COMMUNITY DESIGN REVIEW BOARD STAFF REPORT

AGENDA ITEM: Design Review Resolution, Maplewood Assisted Living, 1744 County Road D East

Engineering Plan Review

Environmental Review

LANDSCAPE AND LIGHTING PLAN

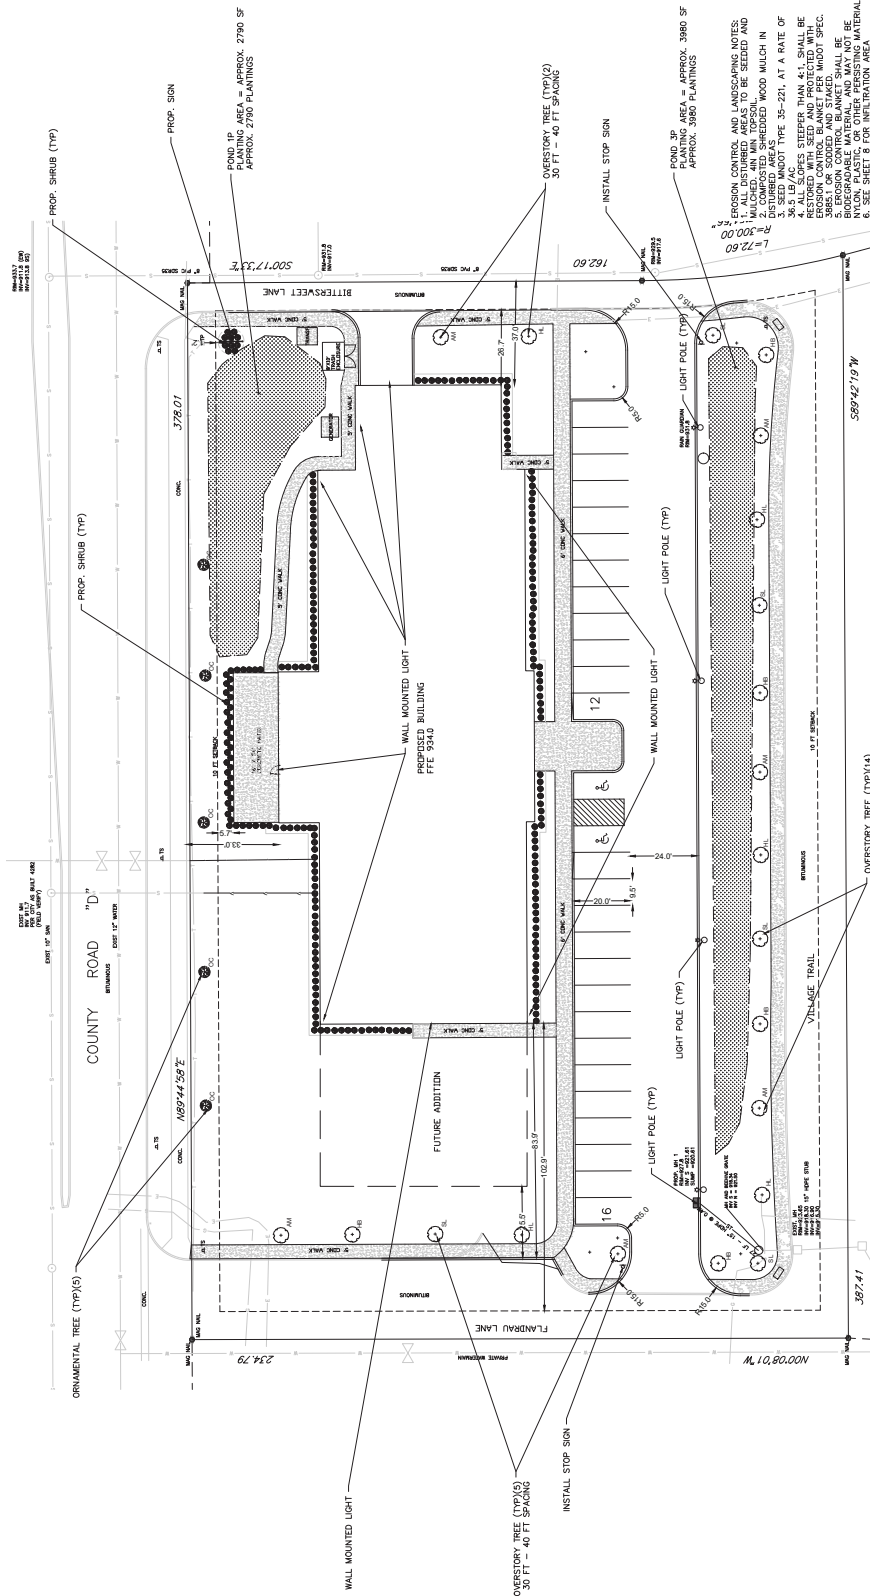
- a) A landscape drawing for each infiltration basin, including list of species, MNDOT seed mix, container size, spacing, and quantities. The plan states "Planting Detail (STD Plate 652) on Sheet 8". No Sheet 8 was included.

- b) The MNDOT seed mix 35-221 is a dry prairie mix and it should work fine in the upper part and slopes of the ponds. The wet areas should include a seed mix such as MNDOT 33-261 for stormwater.

- c) The plan calls for 25 Juncu effusus. The correct spelling is Juncus effuses.
 - d) For any area using a native seed mix (ex: pond slopes), provide a three-year maintenance plan. The plan should include maintenance for each year, including maintenance activities that will be required and what entity (developer, owner, etc.) will take on this responsibility.
